Response to Submissions and Amendments to Proposed Development

Sydney International Convention, Exhibition and Entertainment Precinct (SICEEP)

Darling Square - North Plot and The Square

Submitted to Department of Planning and Environment
On Behalf of Lendlease (Haymarket) Pty Ltd

Figure 1 – Proposed and removed loading and unloading areas for The Darling Exchange

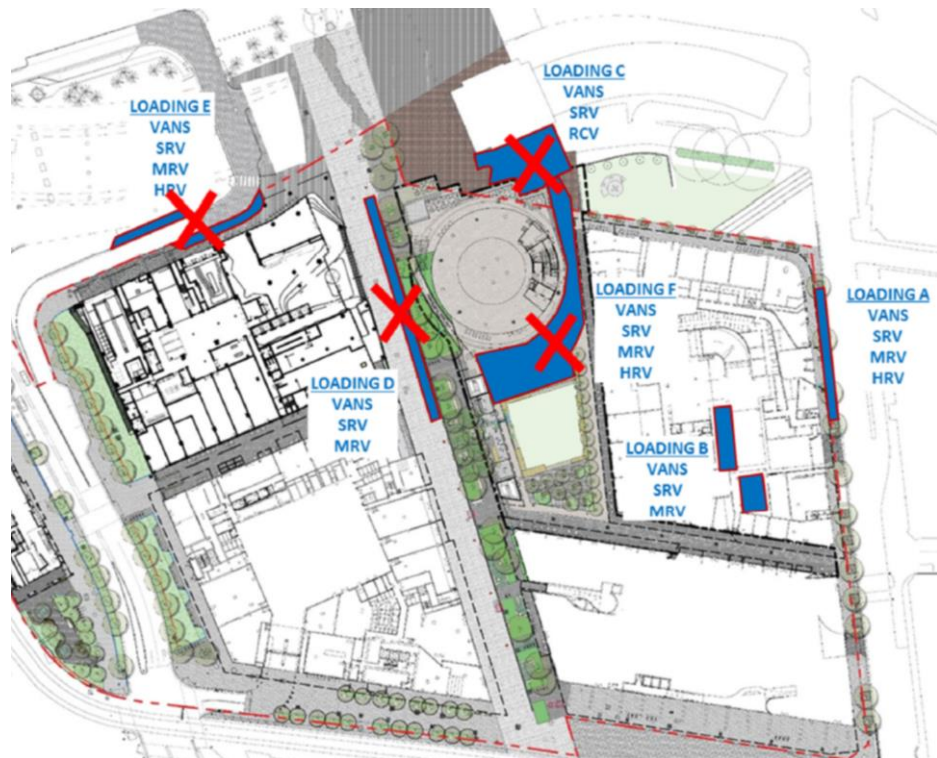
The Department has requested the consideration of revising the location and extent of loading and unloading areas, namely with a view of minimising potential impacts on the public domain and pedestrian safety. Confirmation has been sought by the Department on how pedestrian movements and safety will be safeguarded. The Department has also requested confirmation on the hours of use for the loading areas and any required management/mitigation measures of noise associated with loading between 8:00pm and 10:00pm.

TfNSW suggested that all loading and unloading activities are contained within the site and reliance on kerb side restrictions should be limited. It was also sought by TfNSW that a condition be provided on any development consent requiring the preparation of a loading area management plan.

Place Management NSW also raised several matters for consideration in regards to the use of loading and unloading areas across Darling Square. These comments related to potential impacts on pedestrian movements and amenity. Ultimately, Place Management NSW recommended the use of loading and unloading facilities in the North East Plot.

With this in mind, the loading and unloading strategy for The Darling Exchange has been amended to enable loading and unloading activities to occur within the ground level podium of the approved North-East Plot. The arrangement of the ground level within the North-East Plot is to be the subject of a separate modification application to allow for the following service bays to be used by The Darling Exchange:

- Two (2) x van bays

- Four (4) x SRV bays
- A single x 8.8 metre MRV bay (approved)
- A single x 10.3 metre MRV bay (approved)

Figure 1 illustrates the revised location of loading and unloading areas associated with The Darling Exchange.

Figure 3 – Pedestrian desire lines

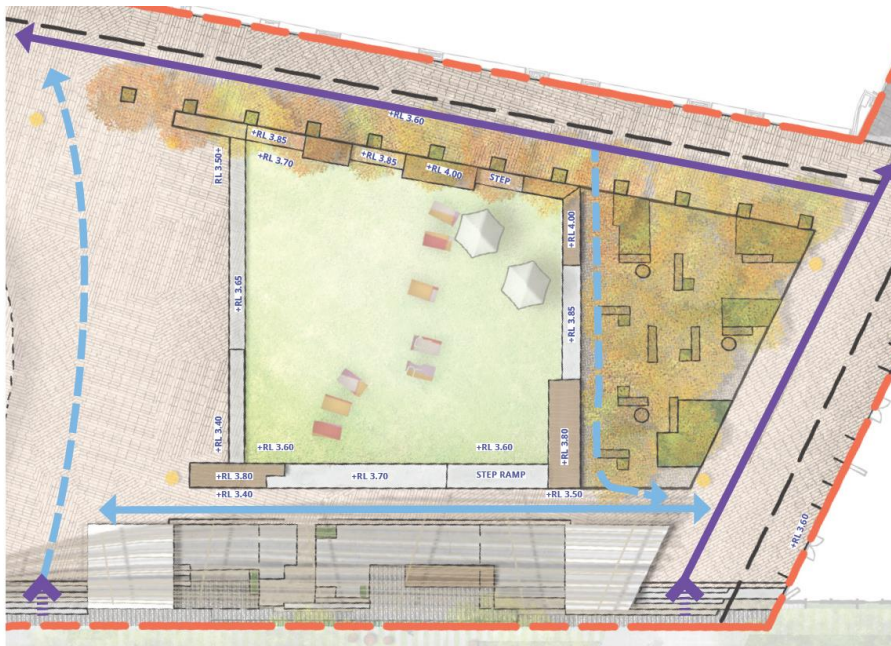
The Department requested justification on the provision of grass within The Square and the selection of tree species. Aspect Studios has provided a detailed response and justification for both of these landscaping treatments (refer to **Appendix D**).

Aspect Studios has consciously designed the pathway network of The Square to accommodate pedestrian movements and encourage particular movement patterns. **Figure 3** illustrates the likely desire lines of pedestrians travelling within and through The Square.

The turfed area has been located in the southern portion of the Square to receive good sunlight. The turf is slightly raised above the level of The Square to give it status in the hierarchy of spaces and to deter pedestrian desire lines across the space. The raising of the turf area enables a small wall edge condition to be achieved, further deterring pedestrian desire lines as people will be able to sit and enjoy the space.

Figure 8 – Stair encroachment into the Boulevard

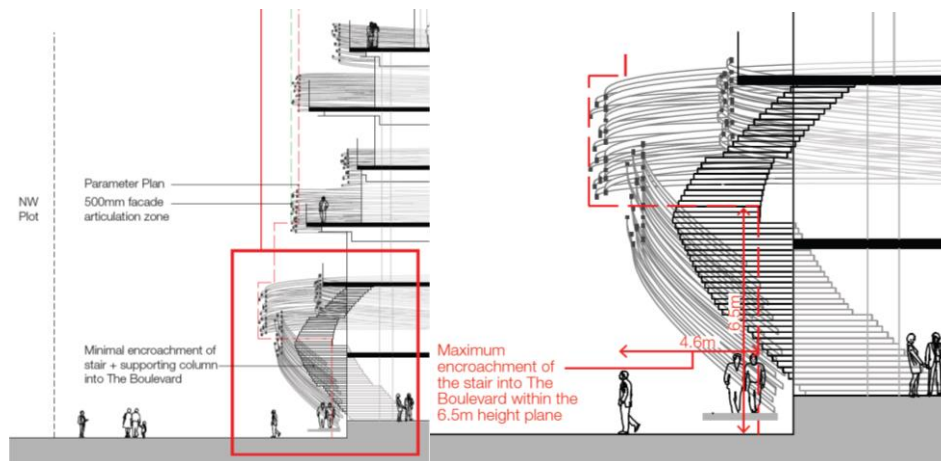
B4A Future Development Applications for the North Plot shall demonstrate compliance with the requirements of Condition A6A and the approved Parameter Plans and the Design Guidelines.

As set out in Section 3.0, the design of the external staircase on The Darling Exchange has been refined to provide a more civic and readable address for the library. The stair has been extended from accessing only the mezzanine level to accessing Level 1. With this change, there has been a requirement to increase the length of the stair and width of the stair at the street level. This amended design was presented to the Design Review Panel on 14 December 2016 and in-principle support was provided for the proposal.

These design moves, when coupled together, result in a stair which requires greater length along the western frontage of the building and a wider presence at street level. In turn, these changes require a slight encroachment of the stair into The Boulevard (set out in **Figure 8**). The project team has worked collaboratively with the guidance of Condition B4A to provide a design outcome which does not restrict pedestrian sight lines; retains pedestrian connectivity; allows for views and does not create visual clutter within The Boulevard. Each of the relevant considerations under Condition B4A are sequentially addressed below.
